To: INCITS Technical Committee T10  
 From: Kevin Butt  
 Date: Monday, July 06, 2009 1:19 pm  
 Document: T10/08-391r5 — SSC-3: Resolution to LB IBM-L1

This proposal intends to resolve LB IBM-L~~2~~1:

## Encryption Parameters in a SCSI device

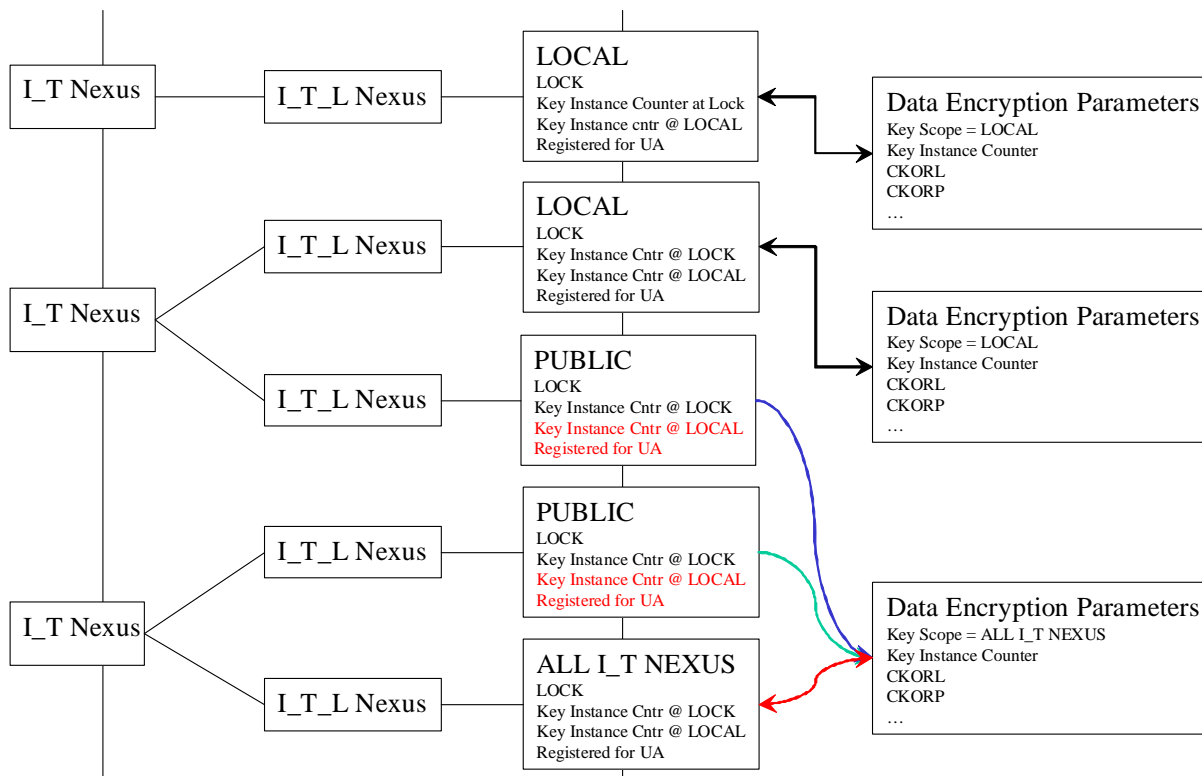
The following figure may help discuss the LOCK bit and what is required for it to function properly. Note that the red text in the figure are parameters that are not present in the specific case.
